# SERVICE BULLETIN

HA05-005

## 2004 – 2005 TITAN AND ARMADA; RATTLE FROM CONDENSER FAN MOUNT

**APPLIED VEHICLES:** 2004 – 2005 Titan (A60)  
2004 – 2005 Armada (TA60)

Figure 1

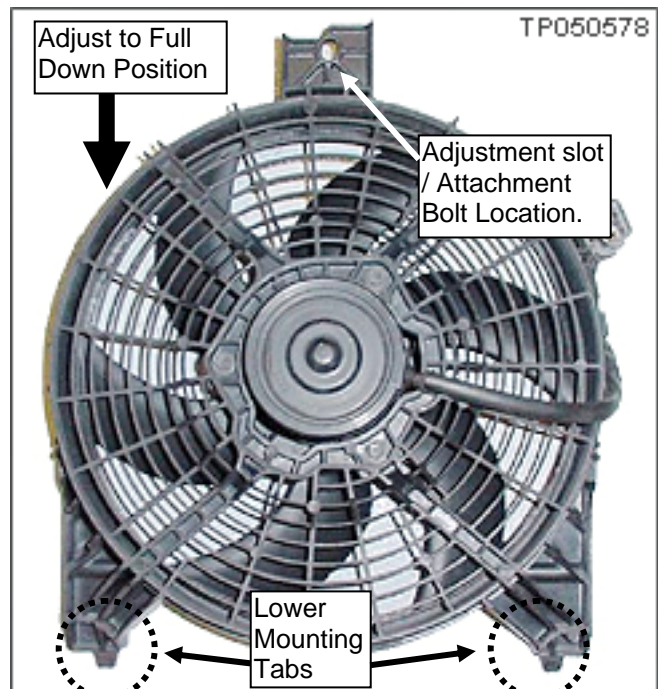
1. Remove the condenser fan and apply felt cloth tape to the lower mounting tabs (see Figure 1, also Figure 2 on the next page).
  - Refer to section CO in the Electronic Service Manual (ESM) for condenser fan (Engine Cooling Fan) removal and installation information.
2. Reinstall the fan using the new attachment bolt listed in the Parts Information.
  - When reinstalling the fan, make sure it's adjusted to the full down position.
  - Make sure the fan assembly does not have looseness or play at the lower mounting tabs.
3. Test drive the vehicle and make sure the rattle is gone.
